MEMORANDUM

SUBJECT: ZC Case No. 20-12 – 400 I Street SW (Westminster Presbyterian Church)

SUMMARY OF DDOT REVIEW

Figure 1. Site Plan (Source: Symmetra Design, February 26, 2021 Transportation Statement Figure 7).

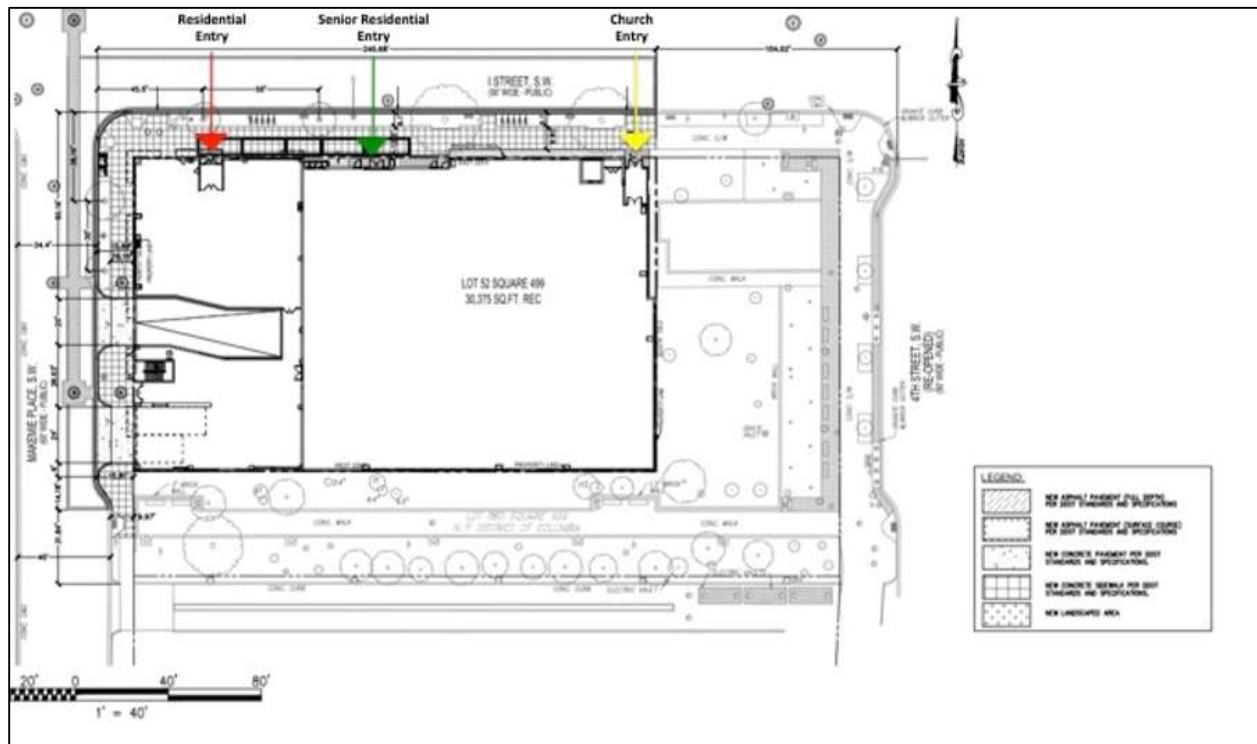
There are three (3) pedestrian access points along I Street SW for the church, senior residence, and residential entry. There are two (2) vehicular access points along Makemie Place SW, one for loading and one for vehicle access to the underground parking garage.

The Applicant is proposing two (2) curb cuts on Makemie Place SW, one of which does not permit head-in/head-out maneuvers for trucks. It is unclear if the curb cut furthest south is 6-ft away from the property line to accommodate the curb radii in the public space adjacent to the property (DEM 31.5.2.f).

Figure 9. Westminster Presbyterian Church Proposed Curbside Restrictions (Source: Symmetra Design, February 26, 2021 Transportation Statement Figure 9).

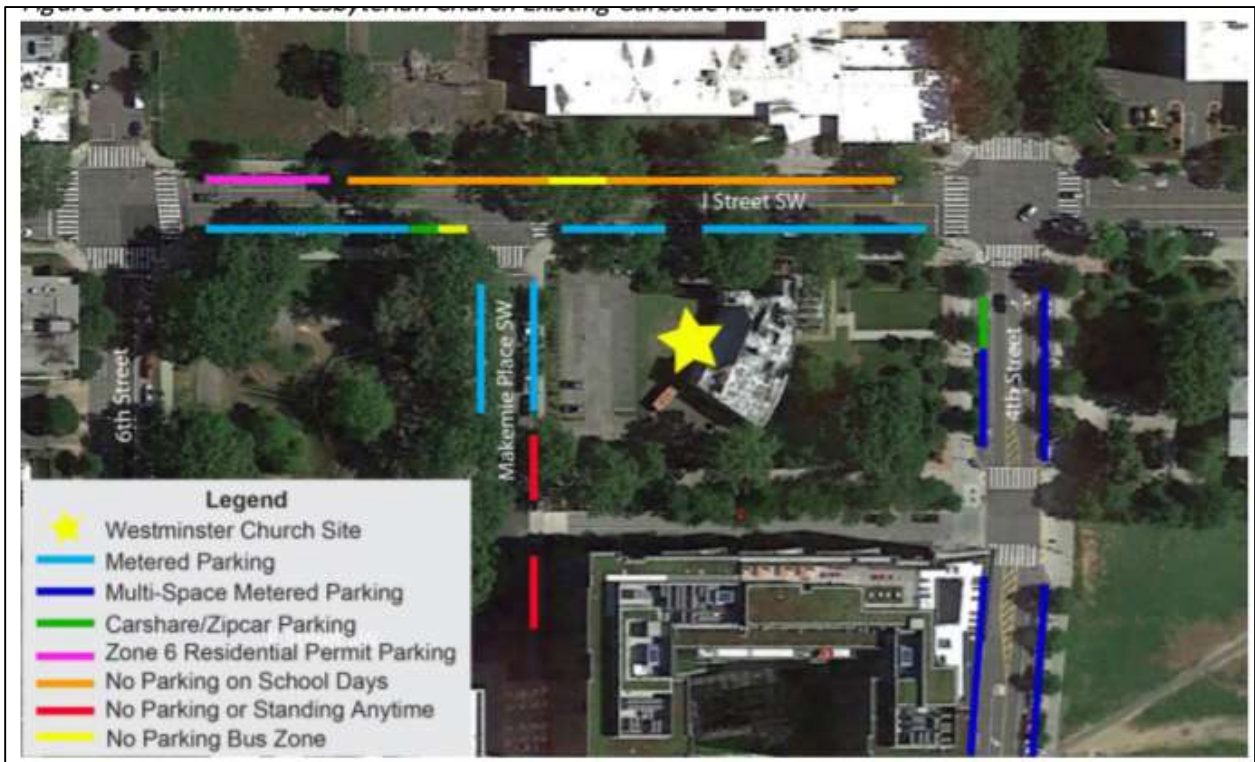
The Applicant will need to work with the DDOT curbside management team during permitting to identify an appropriate curbside management plan that includes the protected bike lane design for I Street SW and updates to the curbside signage and restrictions accordingly. The no-parking entrance will likely need to be reduced to 60-ft and may need to shift entirely towards Makemie Place SW without the breaks as currently shown on the plan.

Figures 8 and 9 below show the existing and proposed curbside restrictions around the site. There is a mix of parking options that are proposed to change with the redevelopment. The Applicant will need to work with the curbside management team during permitting to identify an appropriate curbside management plan that includes any changes on I Street SW as a result of the I Street SW Protected Bike Lane Project. The Applicant will need to work with the DDOT curbside management team during permitting to identify an appropriate curbside management plan that includes updates to the curbside signage and restrictions accordingly. The no-parking entrance will likely need to be reduced to 60-ft and may need to shift entirely towards Makemie Place SW without the breaks as currently shown on the plan.
